Product Advisor (PA)

Subject: Datasheet Correction for the Listed ISL95338 Product Family

Publication Date: 10/29/2018

2.1 Absolute Maximum Ratings Table

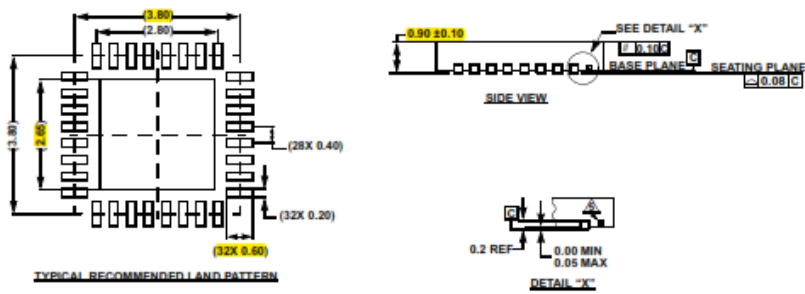
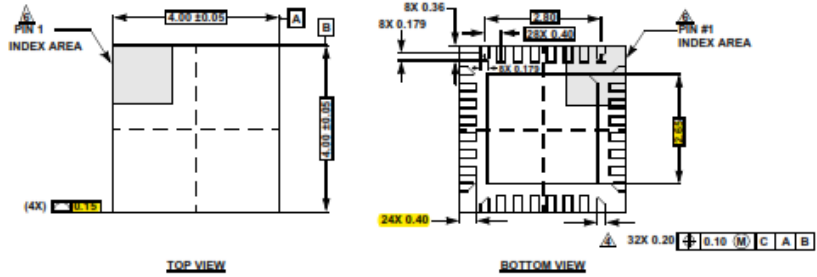
This notice is to inform you that the datasheet associated with the ISL95338* family of products has been updated to correct errors in the absolute maximum rating and the package outline sections of the document. Please refer to appendix A for a complete comparison of the changes.

From:

Parameter	Minimum	Maximum	Unit
CSIP, CSIN, DCIN, ADPS, ADP	-0.3	+30	V
CSIP	0.3	ADP + 2	V
PHASE1	GND - 0.3	+30	V
PHASE1	GND - 2 (<20ns)	+30	V
UGATE1	PHASE1 - 0.3	BOOT1 + 0.3	V
PHASE2	GND - 0.3	+30	V
PHASE2	GND - 2 (<20ns)	+30	V
UGATE2	PHASE2 - 0.3	BOOT2 + 0.3	V
LGATE1, LGATE2	GND - 0.3	VDDP + 0.3	V
LGATE1, LGATE2	GND - 2 (<20ns)	VDDP + 0.3	V
VOUT, VOUTS, CSOP, CSON	-0.3	+27	V
VDD, VDDP	-0.3V	+6.5	V
BOOT1, BOOT2	- 0.3	VDDP + 27	V
BOOT1	(PHASE1 - 0.3)	PHASE1 + 6.5	V
BOOT2	(PHASE2 - 0.3)	PHASE2 + 6.5	V
COMPR, COMPF, REF, PROG	-0.3	+6.5	V
RVSEN, FRWEN, ADDR0, ADDR1	-0.3	+6.5	V
FRWPG, PROCHOT#, RVSPG	-0.3	+6.5	V
SCL, SDA	-0.3	+6.5	V
BOOT1-PHASE1, BOOT2-PHASE2	-0.3	+0.3	V
CSIP-CSIN, CSOP-CSON		2	mA

To:

Parameter	Minimum	Maximum	Unit
CSIP, CSIN, DCIN, ADPS, ADP	-0.3	+30	V
CSIP	0.3	ADP + 2	V
PHASE1	GND - 0.3	+30	V
PHASE1	GND - 2 (<20ns)	+30	V
UGATE1	PHASE1 - 0.3	BOOT1 + 0.3	V
PHASE2	GND - 0.3	+30	V
PHASE2	GND - 2 (<20ns)	+30	V
UGATE2	PHASE2 - 0.3	BOOT2 + 0.3	V
LGATE1, LGATE2	GND - 0.3	VDDP + 0.3	V
LGATE1, LGATE2	GND - 2 (<20ns)	VDDP + 0.3	V
VOUT, VOUTS, CSOP, CSON	-0.3	+24	V
VDD, VDDP	-0.3V	+6.5	V
BOOT1, BOOT2	- 0.3	VDDP + 25	V
BOOT1	(PHASE1 - 0.3)	PHASE1 + 6.5	V
BOOT2	(PHASE2 - 0.3)	PHASE2 + 6.5	V
BOOT1-PHASE1, BOOT2-PHASE2	-0.3	+6.5	V
COMPR, COMPF, REF, PROG	-0.3	+6.5	V
RVSEN, FRWEN, ADDR0, ADDR1	-0.3	+6.5	V
FRWPG, PROCHOT#, RVSPG	-0.3	+6.5	V
SCL, SDA	-0.3	+6.5	V
CSIP-CSIN, CSOP-CSON	-0.3	+0.3	V
RVSEN, FRWEN, SDA, SCL, FRWPG, RVSPG, PROCHOT#		2	mA
